CCEC-25-004

Christopher M. Crane Clean Energy Center
Renewed Facility License No. DPR-50
NRC Docket No. 50-289

Subject: License Amendment Request - Application to Revise Renewed Facility License and Permanently Defueled Technical Specifications to Support Resumption of Power Operations

FIGURE 3.5-1

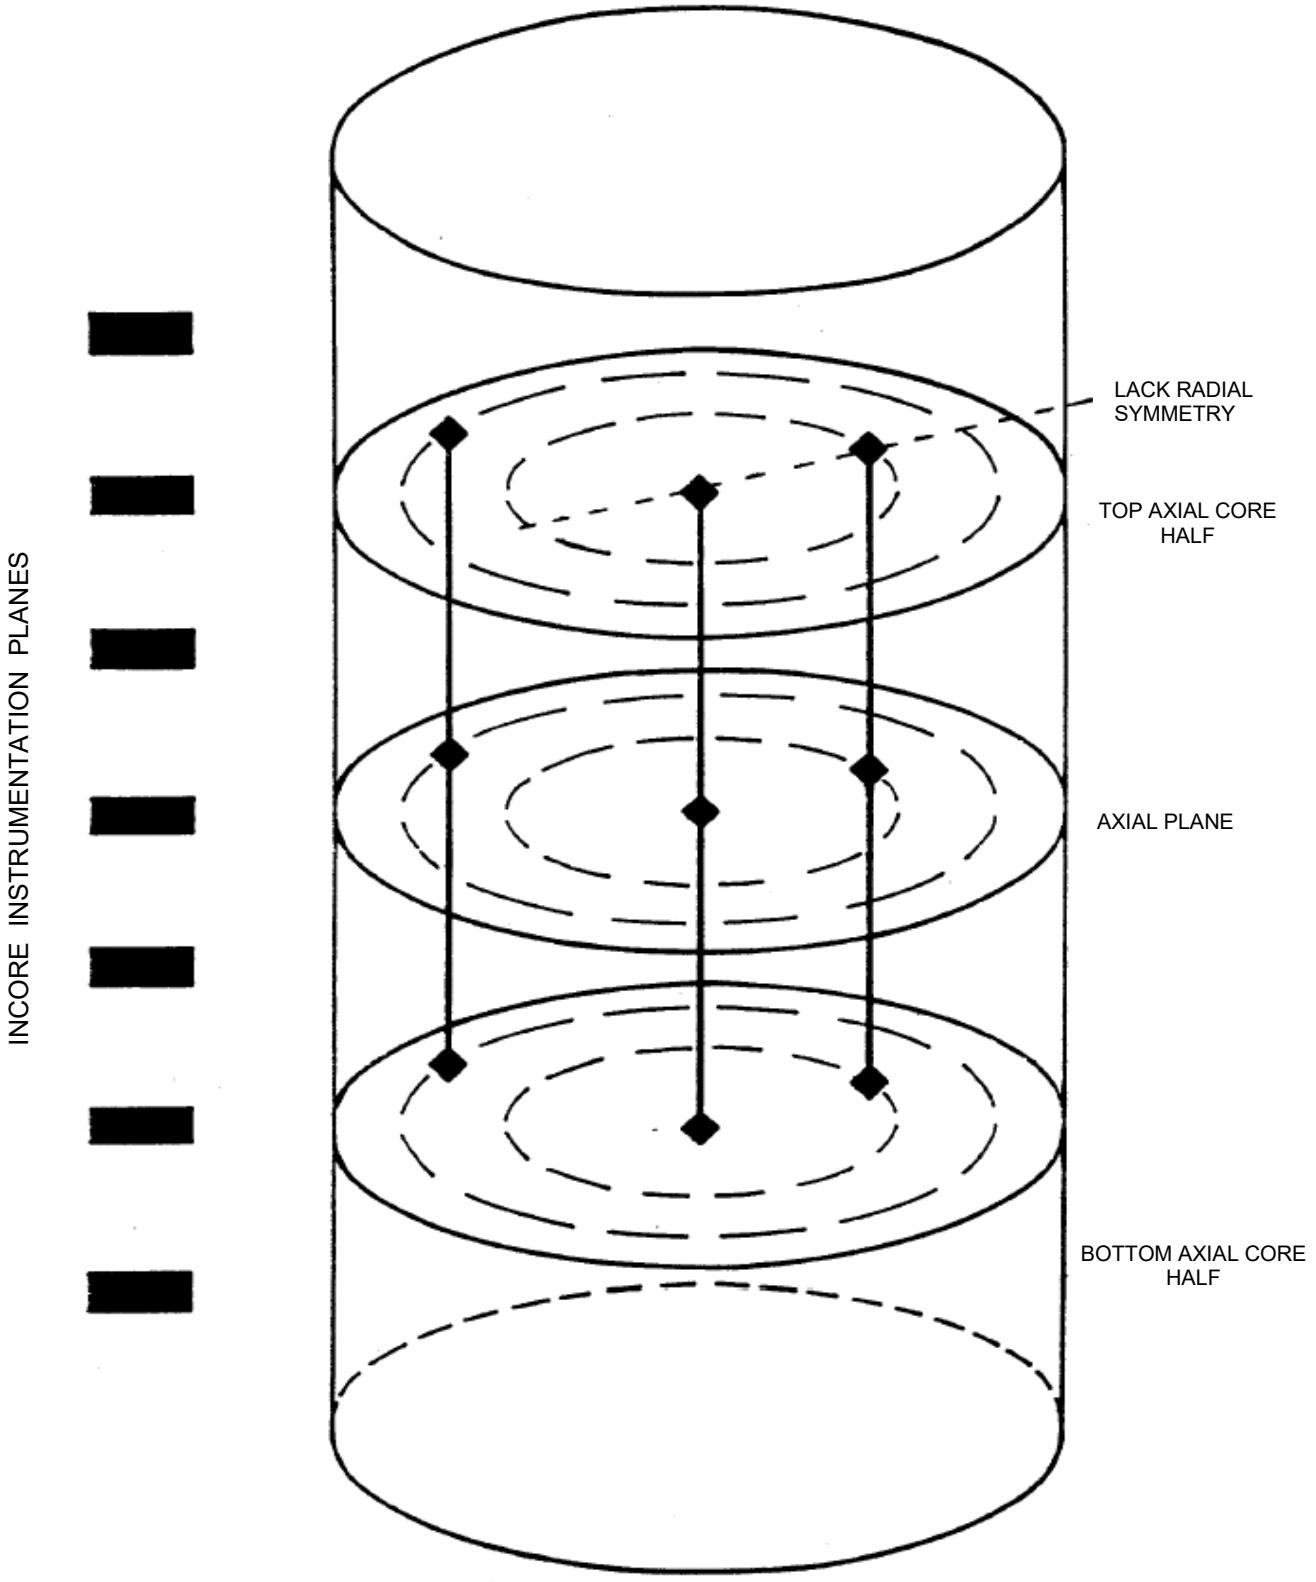
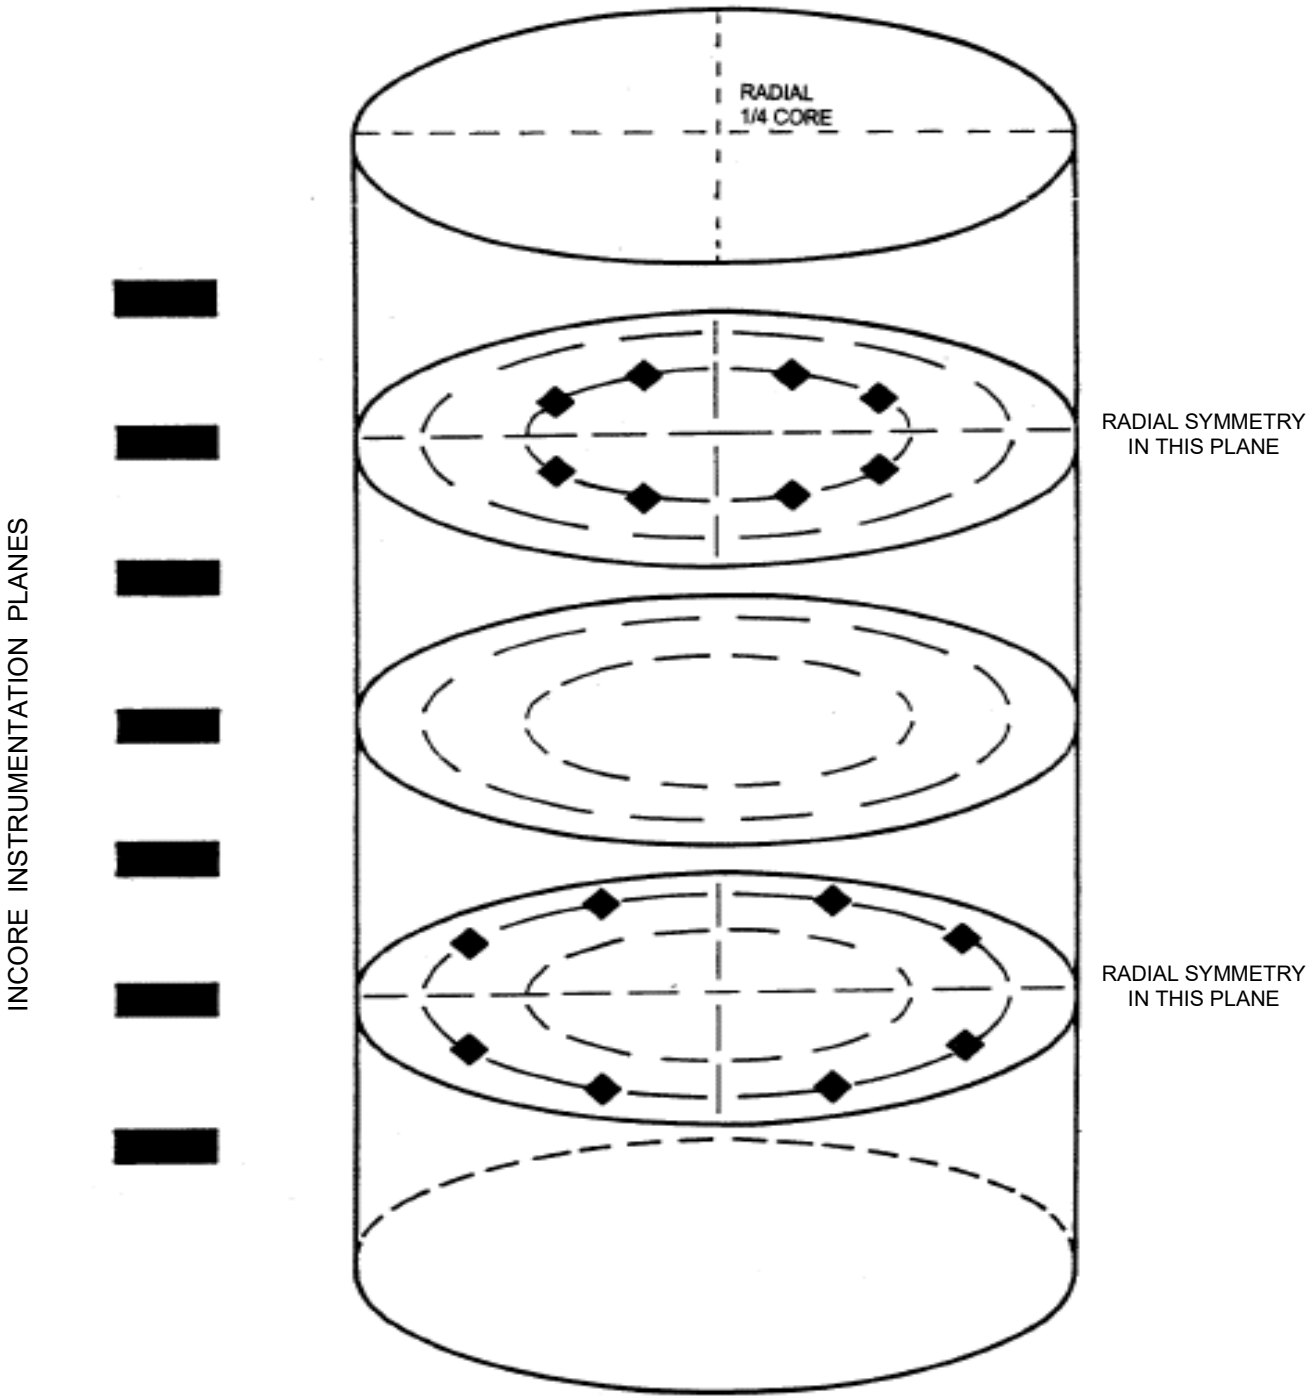
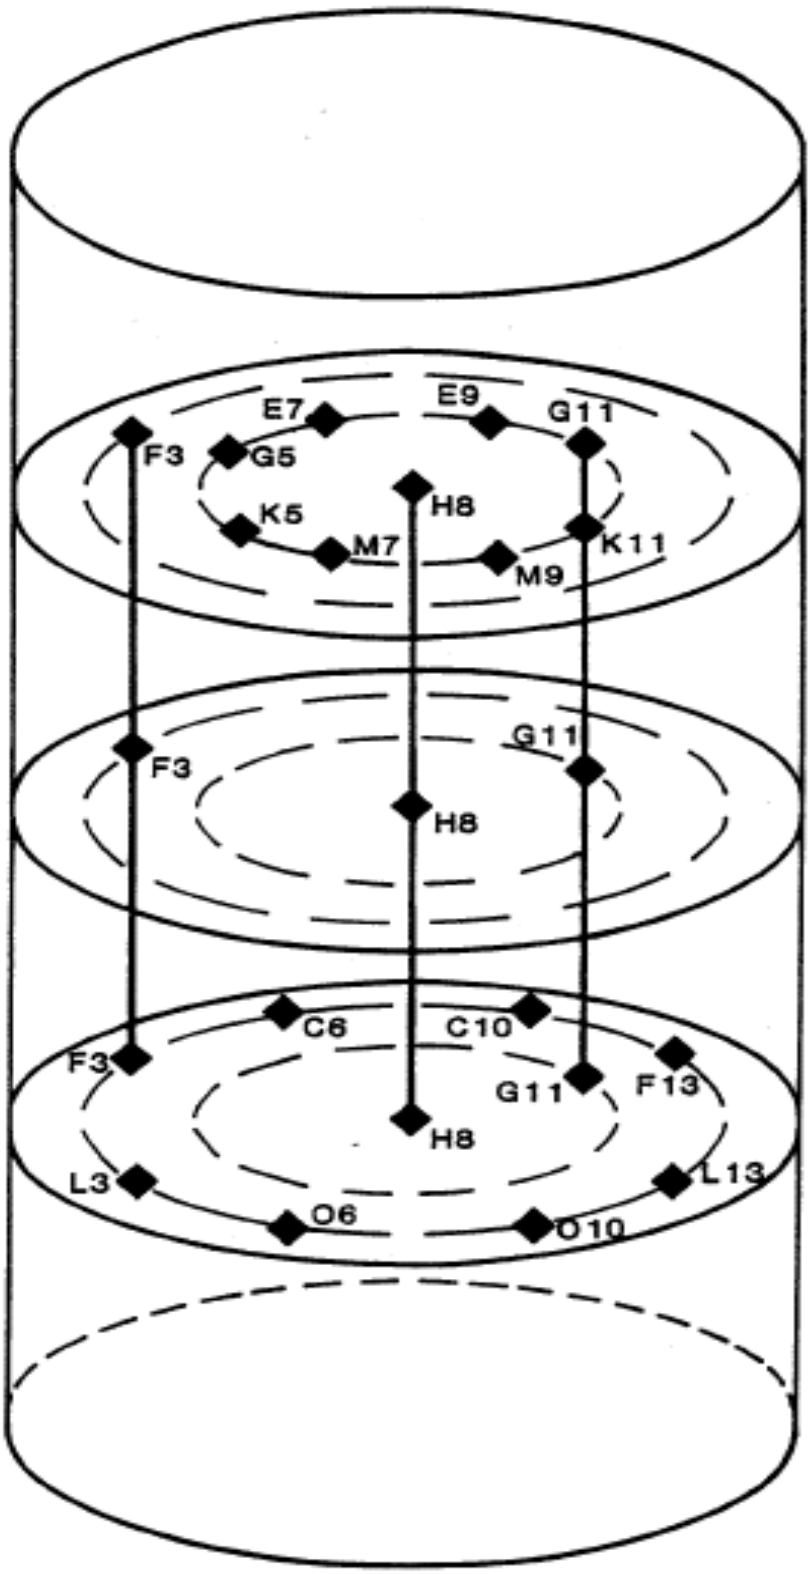
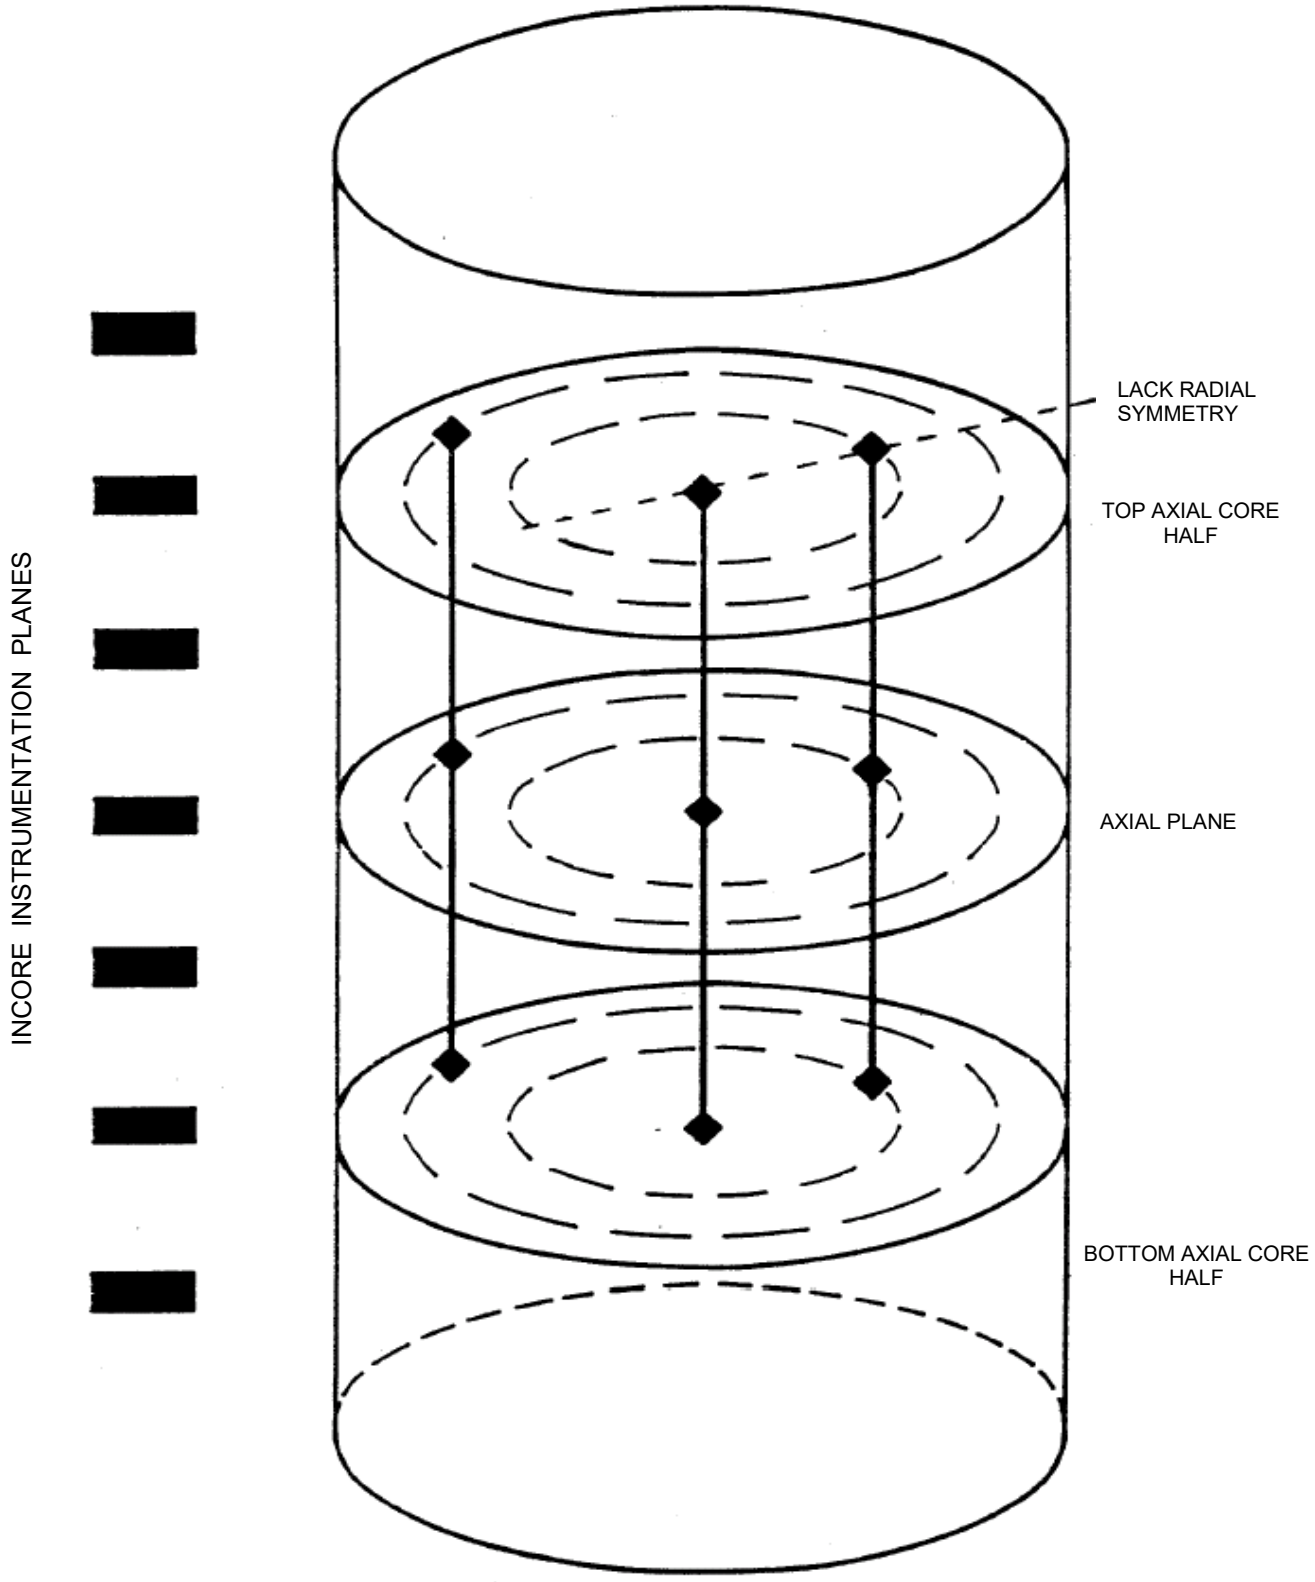
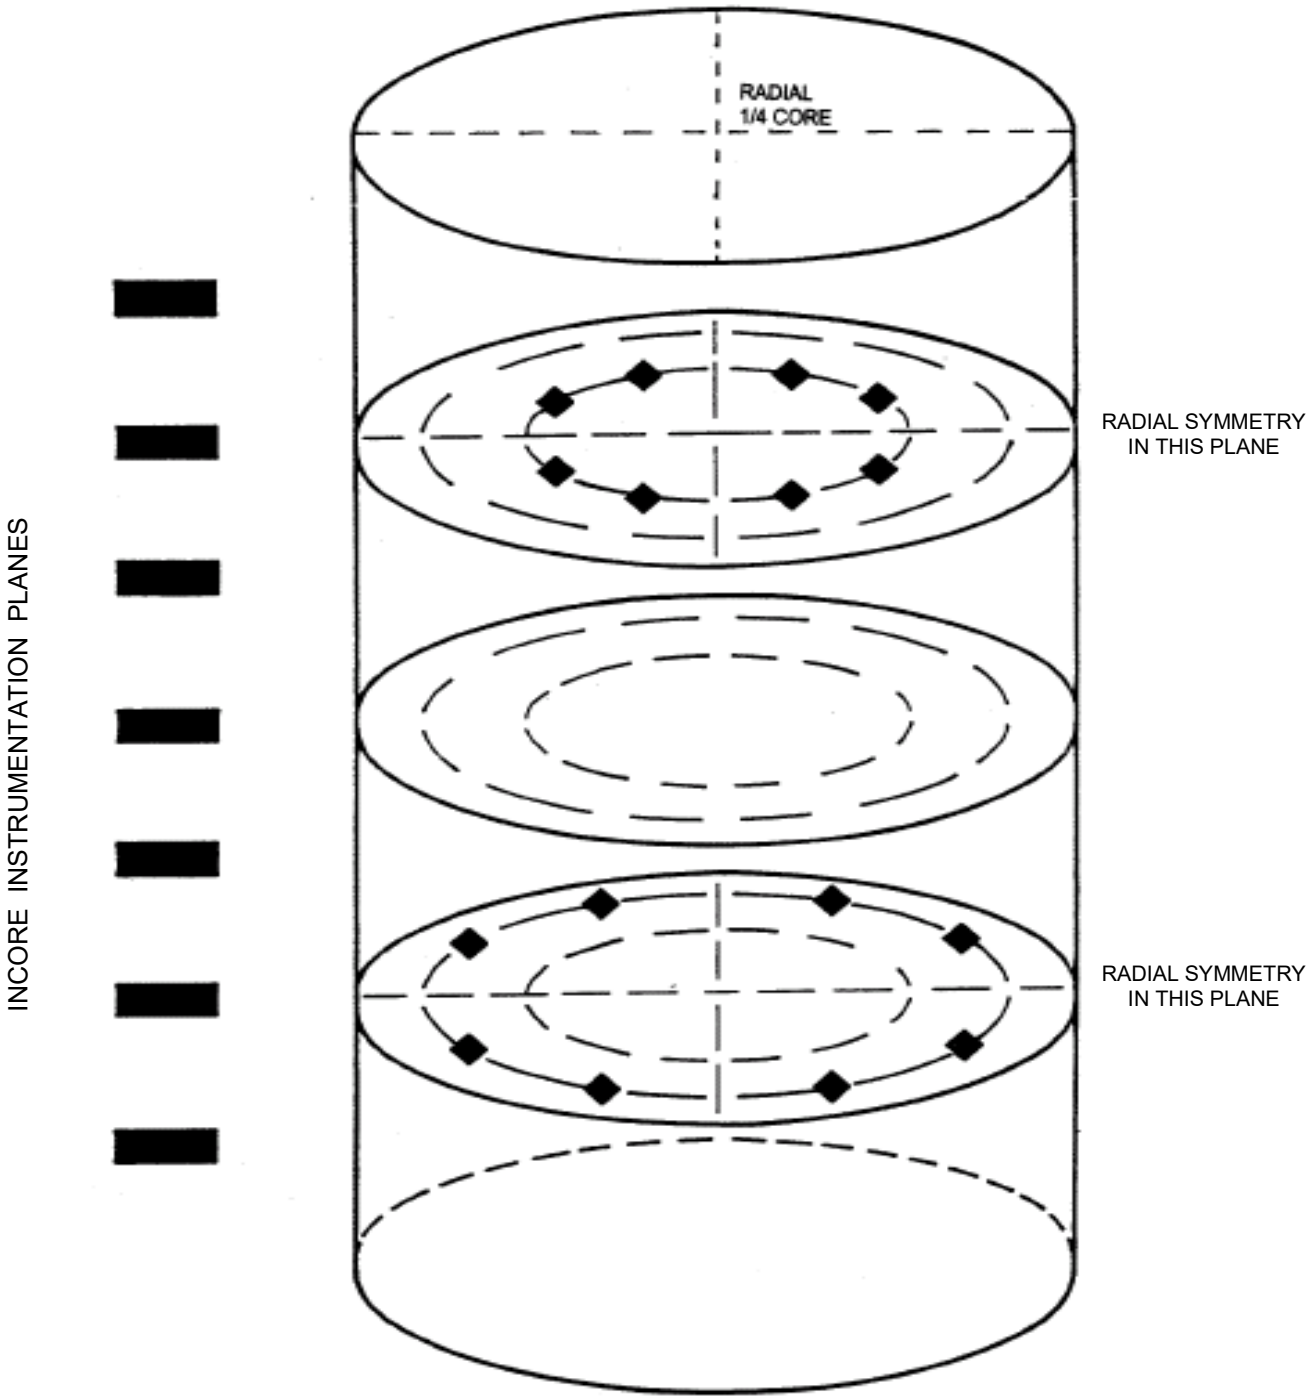
LCO 3.5.4 – Incore Instrumentation (deleted)	LCO 3.5.4, Incore Instrumentation, was previously deleted by Amendment 211 (ML003765996). Figure 3.5-1, Incore Instrumentation Specification Axial Imbalance Indication, Figure 3.5-2, Incore Instrumentation Specification Radial Flux Indication, and Figure 3.5-3, Incore Instrumentation Specification aid in determining the functionality of the full incore system for measurement of QPT and axial power imbalance specified in LCO 3.5.2. Figures 3.5-1, 3.5-2, and 3.5-3 are being reinstated in the proposed change, consistent with Amendment 294 of the TS.
LCO 3.5.5 – Accident Monitoring Instrumentation	LCO 3.5.5, Accident Monitoring Instrumentation, establishes requirements for accident monitoring and post-accident monitoring instrumentation specified in Table 3.5-2, Accident Monitoring Instruments, and Table 3.5-3, Post Accident Monitoring Instrumentation, respectively. This specification satisfies Criterion 3 of 10 CFR 50.36(c)(2)(ii).
